SUBJECT: Forwards response to questions re Insp Rept 50-220/96-05 & technical questions re engineering calculations & analyses related to problem.

Subject: Response to Questions in Enclosure 2 of Inspection Report 50-220/96-05

NINE MILE POINT UNIT 1 REACTOR AND TURBINE BUILDING BLOW-OUT PANELS NRC SPECIAL INSPECTION REPORT NO. 50-220/96-05, 50-410/96-05 RESPONSE TO TECHNICAL QUESTIONS

ISOMETRIC VIEW OF THE MODEL

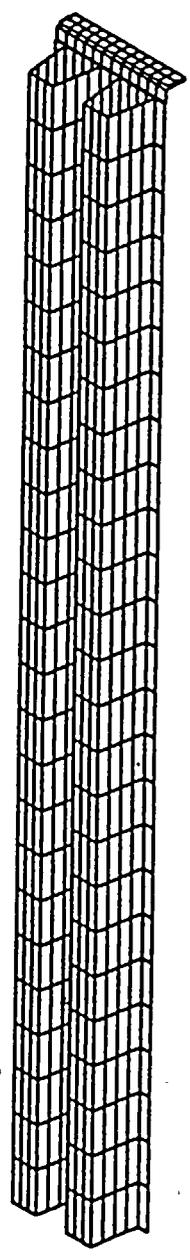
QUESTION 6a: The calculation of the pressure capacity of the top and bottom connections do not consider the membrane effect of the panel in the longitudinal (vertical) direction and the effect of the flexibility of the side connections between the flutes and the columns. In addition, the effect of friction between the bolts and the sheet metal surfaces, due to bolt pre-loading, has not been considered.

Regarding the effect of flexibility of the side connection, Niagara Mohawk completed a finite element analysis of a 24" FKX panel spanning horizontally using the ADINA computer code. The panel was represented by plate elements. The mesh size was fine enough to model the 3/8" bolts holding the panels to the angle irons. The 1/4" shear bolt was also included in the model. The isometric view of the model that was analyzed is attached. (Figure 1)

The large displacement option in ADINA was used to calculate the bolt tension as a function of applied pressure. The result of this evaluation compared the ratio of the tension in the shear bolt as calculated by ADINA to the tension as it would be calculated by simple analysis (from the moment equilibrium of the 3"x2"x1/4" angle for a given bearing force on the angle leg resulting from the pressure load). The resulting ratio depends on the value of applied pressure. At 60 psf, tension ratio of the ADINA to the simple method is 1.02; at 120 psf this ratio is 1.06. This analysis demonstrates that the effects of the side connections are insignificant, however, they have been incorporated, through the use of the ADINA program, into the results presented in the introduction.

Fig. 4.13. Shear strength versus tensile strength. *Note.* Each point represents the average values of a specific bolt lot. The shear strength is computed on the relevant area, depending on the location of the shear plane.

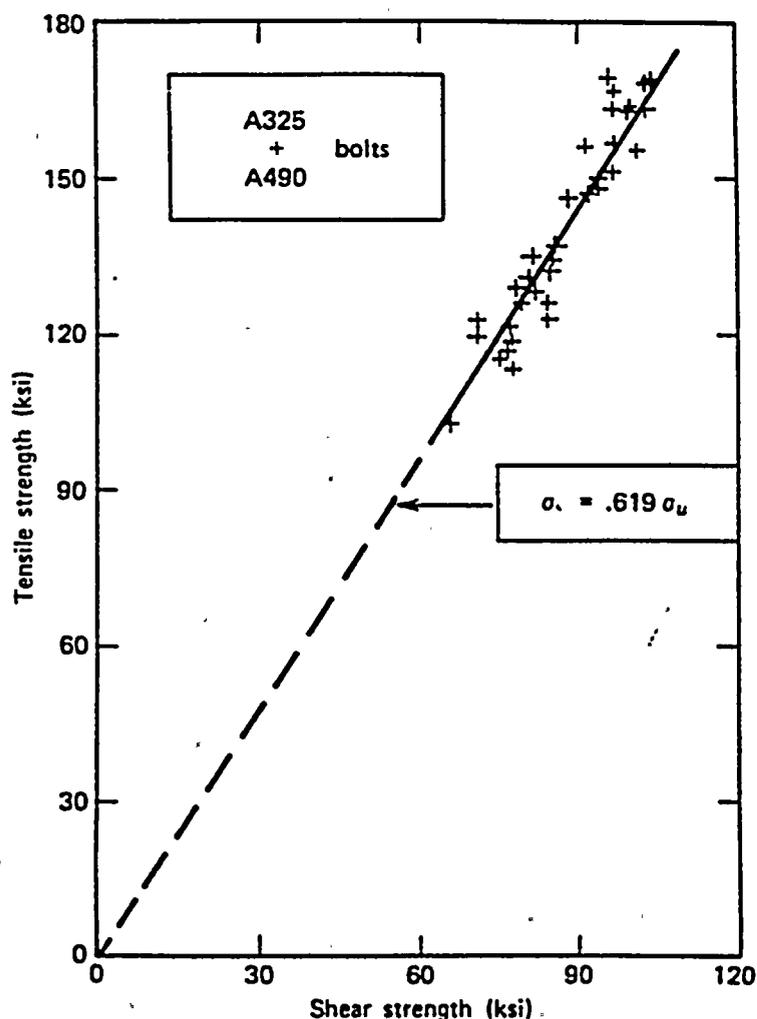
QUESTION 8b: What is the test-verified ultimate shear strength of the same set of bolts tested?

ANSWER 8b: Shear tests were not performed. Adequate information on the relationship between shear and tensile strength for bolts exists. The attached Figure 2 (Page 47 from Reference 1) shows that the ratio between shear strength to tensile strength does not depend on the bolt grade.
